Agenda Item: 9.3.1 (new agenda)
Source: Nokia
Title: Procedures to release a dedicated physical channel
Document for: Decision

3. Changes to S2.03

Figure 1: RRC Connection release from a dedicated channel

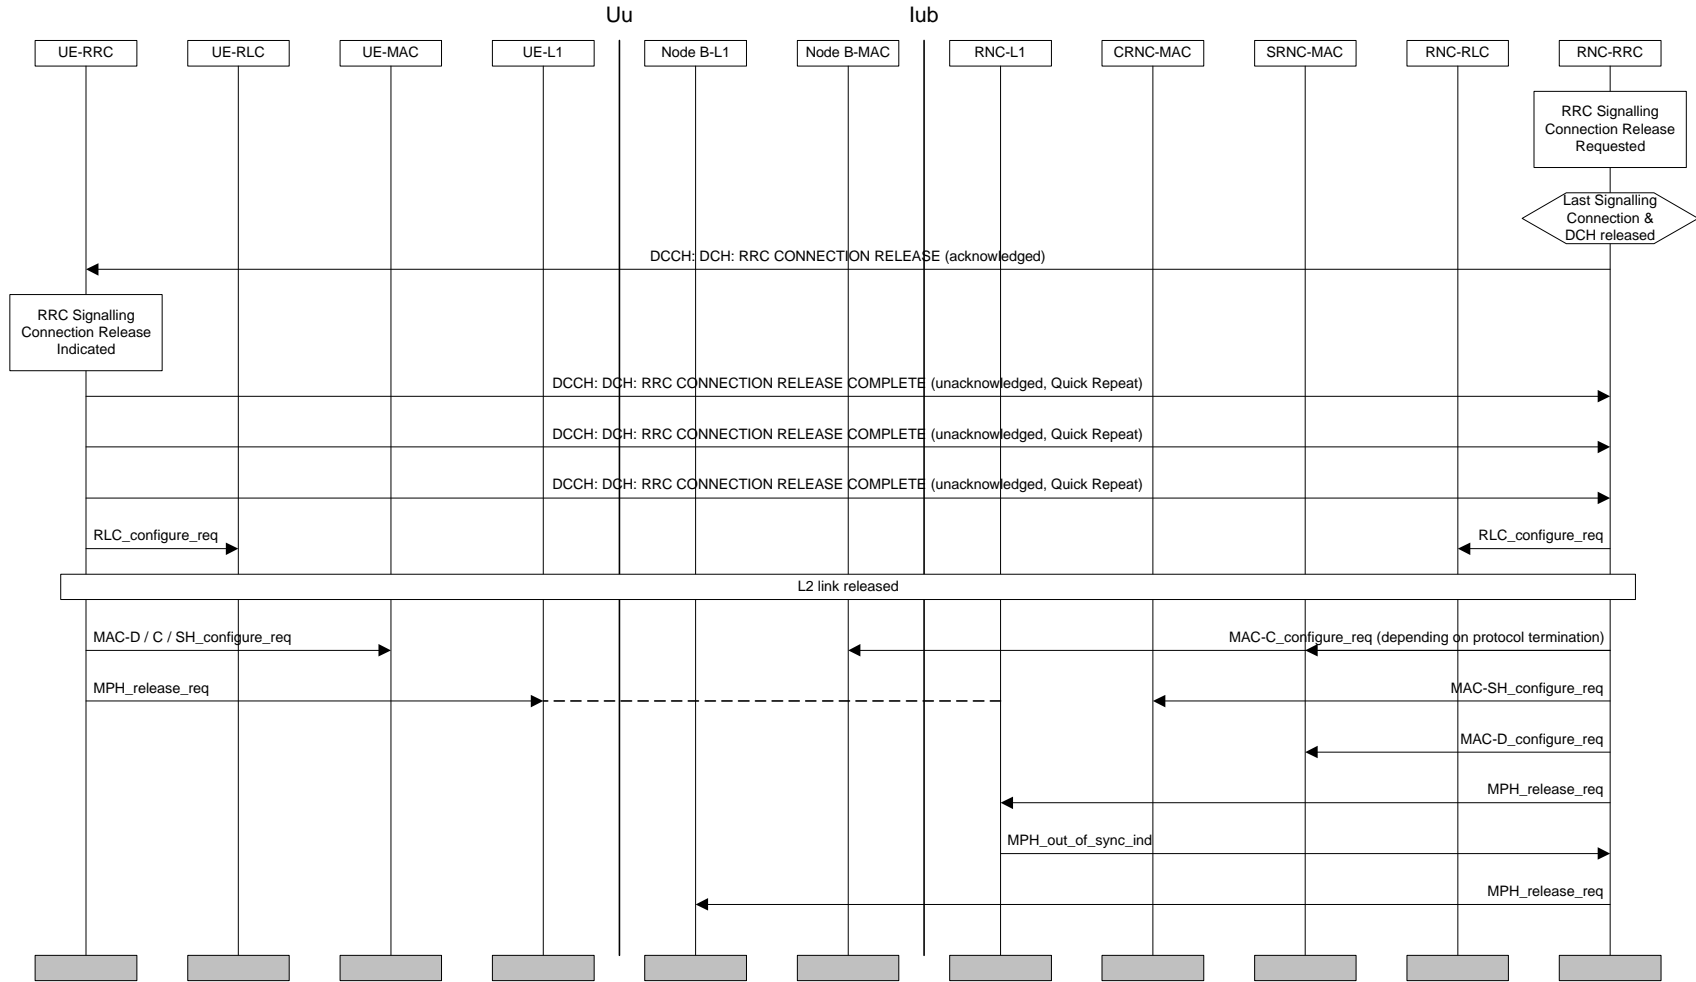
The UE replies with an RRC CONNECTION RELEASE COMPLETE message, which is sent in unacknowledged-mode on the dedicated channel. To improve the reliability of the message, quick repeat on RRC-level can be used. The UE will then proceed to release RLC(s), MAC and the radio link(s) after which ~~and requests the release of the radio link(s), MAC and RLC(s).~~ After that the UE RRC enters Idle Mode.

The primary method to detect the release of the signalling link in the NW is the RRC CONNECTION RELEASE COMPLETE-message from the UE. Should the message be lost despite the use of quick repeat, ~~t~~The release of the signalling link is detected in the UTRAN by the out-of-sync primitive from either Node-B L1 or RNC-L1 (FFS) to RNC RRC. After receiving this primitive, the RNC-RRC layer releases L2 and L1 resources on the network side and enters the idle mode.

Figure 2: UE-terminated DCH release

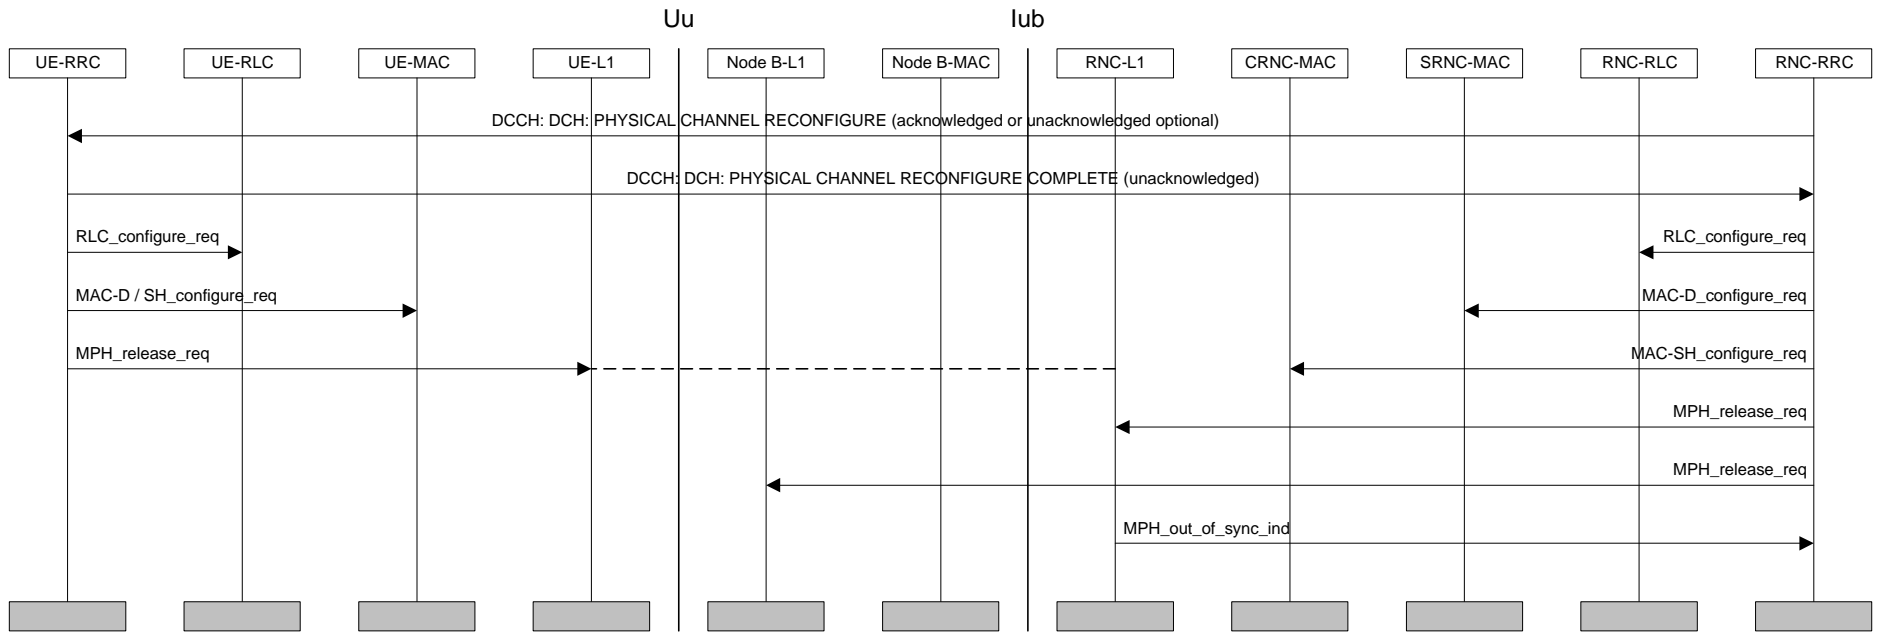
Figure 2 illustrates an example of a procedure for a switch from dedicated (DCH) to common (RACH/FACH) channels. All DCHs used by a UE are released and all dedicated logical channels are transferred to RACH/FACH instead. Triggering of this procedure could for example be an inactivity timer.

After reception of the PHYSICAL CHANNEL RECONFIGURE the PHYSICAL CHANNEL RECONFIGURE COMPLETE message to the NW is sent on the existing DCH prior to release in unacknowledged mode. UE reconfigures L2 and L3 to release old DCH resources. The PHYSICAL CHANNEL RECONFIGURE COMPLETE (need FFS) message to the network is here sent on DCCH mapped on RACH (message acknowledgement on FACH). This message triggers a normal release of L2 and L3 resources in the network associated with the dedicated channel. If the L3 COMPLETE message is lost doesn't exist, the MPH_out_of_sync_ind from the physical layer must be applied.

[Note3: In this procedure no quick repeat is currently thought to be necessary for the PHYSICAL CHANNEL RECONFIGURE COMPLETE message. When a Switch to RACH/FACH is done it is important to free the old code as fast as possible so that it can be reused. Therefore instead of waiting for the Physical Channel Reconfigure Complete message the network can reconfigure L1 and L2 when the acknowledged data confirmation arrives and the network is sure that the UE has received the Physical Channel Reconfigure message. To be even more certain that the UE has released the old DCH resources the network can wait until after the Out of sync Indication from L1.]
